CITY OF WICHITA

Wichita-Sedgwick County Metropolitan Area Planning Department

Re: **BZA2026-00025:** Administrative Adjustment in the City to increase the allowable height of an accessory structure by 20 percent (from 21 to 25.2 feet) on property zoned TF-3 Two-Family Residential District, generally located one-block north of East Murdock Avenue and one-quarter mile east of North Hillside Avenue (3402 East Orchard Ave.).

SITE PLAN (Accessory Apartment)

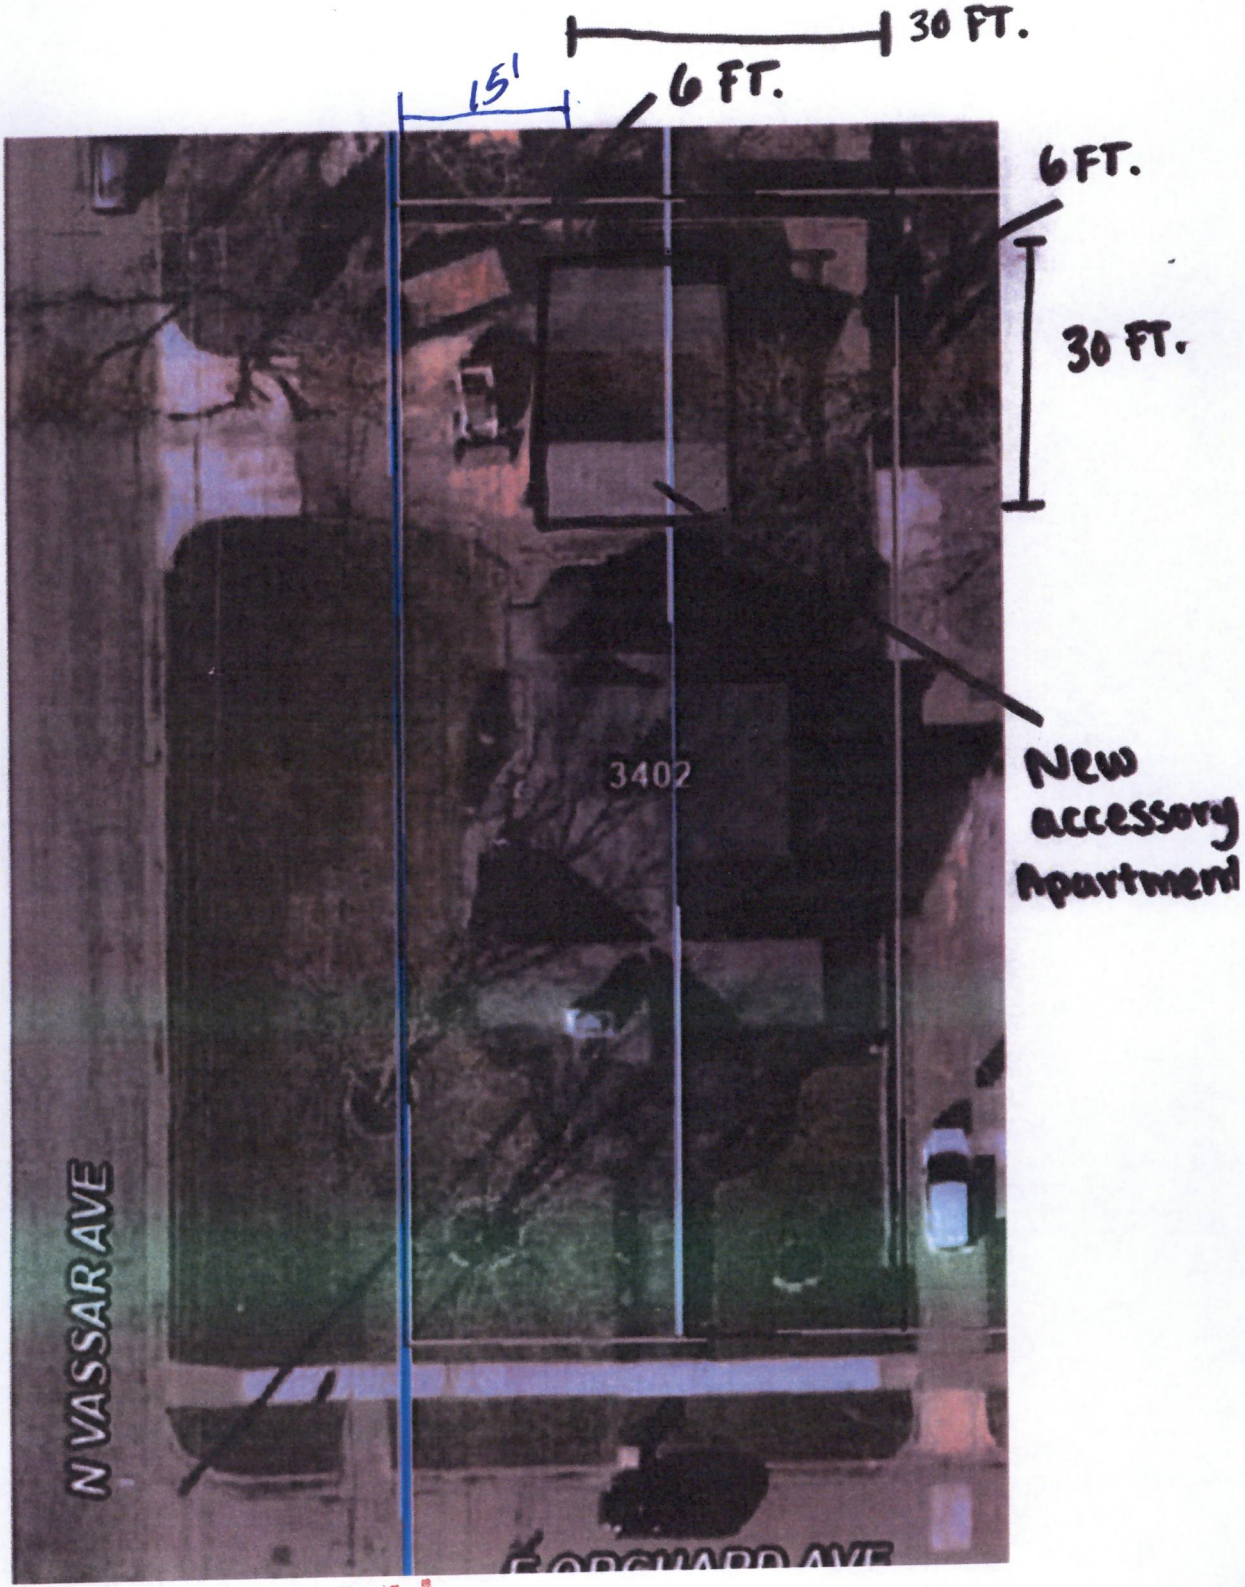
1) The site shall be developed in general conformance with the approved site plan.

4) The height adjustment shall only apply to the 25.2-foot-tall accessory structure in the rear of the property as illustrated on the approved site plan and elevations. All other structures on the subject property shall conform to the height permitted by the Unified Zoning Code unless a separate Zoning Adjustment or Variance is granted.

2 FRONT VIEW

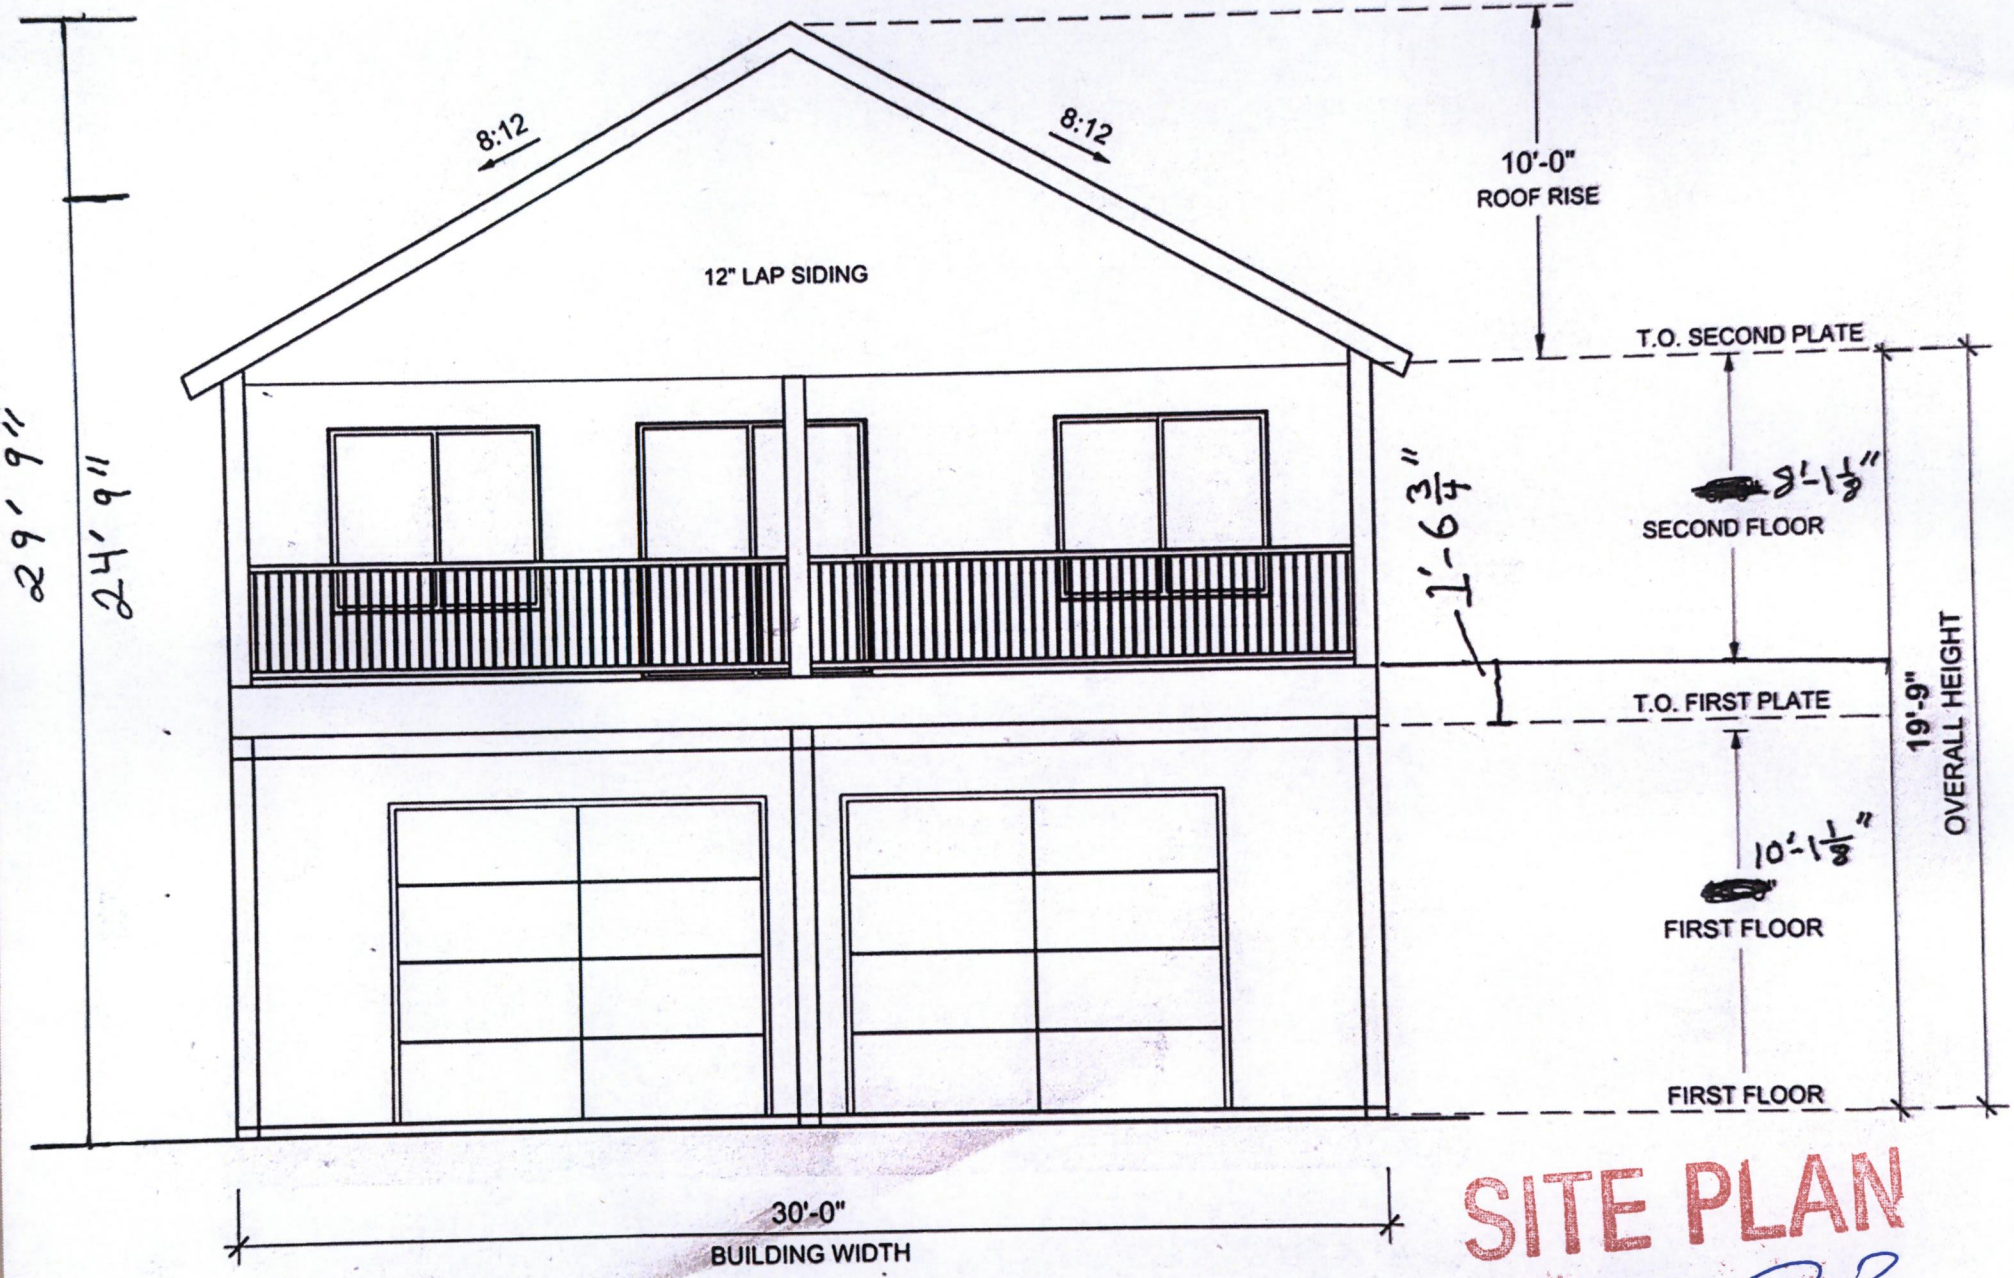
3) The applicant shall submit revised elevations illustrating the structure conforming to the 25.2 height restriction.
